Compatibility LMK 1005 / LMK 1010 to predecessor

Customer information#6/2016

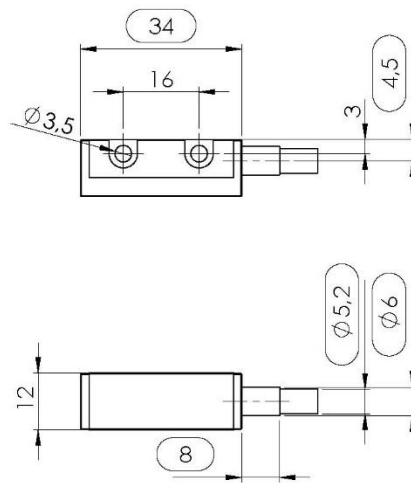
Angle encoders with TTL Interface and an interpolation factor of 1000 (which means a resolution of 0,25 μ m arc length based on a grating period of 1000 μ m) won't show up any more as a price list device.

But there is a backward compatible version available to continue existing applications.

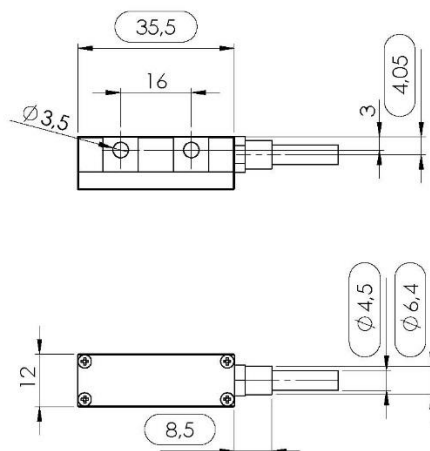
The mechanical dimensions are identical except an improved cable gland (optimizing EMI behaviour) compared to the previous version.

Mechanical dimensions shown in the following drawings. Differences in mechanical dimensions are indicated.

old generation

new generation
